Recall Campaign

October 2018
FL787A
NHTSA#18V-561

Subject: TBB SynTec S3B Floor Mounted Seats

Models Affected: Specific Thomas Built Buses Saf-T-Liner C2 buses manufactured February 26, 2018, through July 4, 2018, with certain SynTec Seating Solutions floor mounted S3B seats.

Figure 1: Location of the Affected Seat Foot

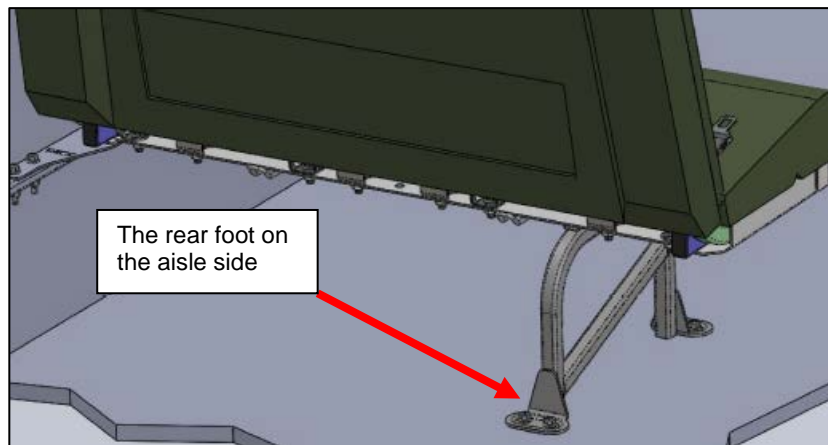
Certain SynTec S3B seats failed to meet the requirements of the FMVSS 210, Seat Belt Anchorages, pull test. If the seat mounting foot were to detach from the floor of a bus during a crash, there would be an increased risk of injury.

1. Park the vehicle, shut down the engine, make sure the shifter is in Park/Neutral, set the emergency brake, chock the tires.
2. Locate the rear foot on the aisle side of each 45 inch S3B seat on the bus (there will be between 1 and 10 seats). See **Figure 1**.

Washers will be added between the rear mounting foot and the bus floor bolt heads to increase the surface contact of the bolted joint.

Figure 2: Hardware Installation Locations

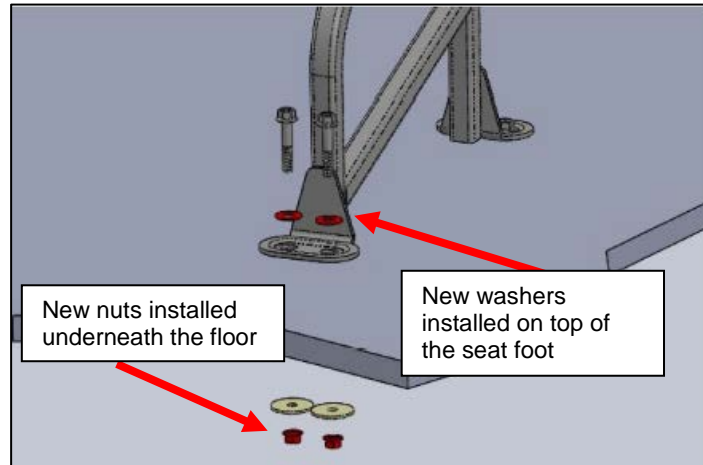
3. Using a 9/16 inch combination wrench, the person outside the bus will hold the nut underneath the bus steady. Using a 3/8 inch drive socket with a 9/16 inch deep well socket, the person inside the bus will remove the bolt. Repeat for the second nut/bolt.
4. Retain the two washers and discard the two nuts (underneath the bus). If there were any other brackets or mounting hardware, reinforcements, etc. (inside the bus), retain for reinstallation.
5. Remove the bolts (inside the bus) and add one new washer to each bolt then reinsert each bolt through the foot of the seat and the floor of the bus. Reinstall any hardware removed in step 4 above in the same location as the bolts are reinserted. See **Figure 2**.
6. Install new nuts and the existing washers on the bolts from underneath the bus. See **Figure 2**.

7. Using a torque wrench with 9/16 inch socket, tighten the bolts to 14 foot pounds.
8. Spray rubberized undercoating over the area where the bolts come through the floor of the bus.
9. Repeat for each 45 inch S3B seat.
10. Remove the chocks from the tires.
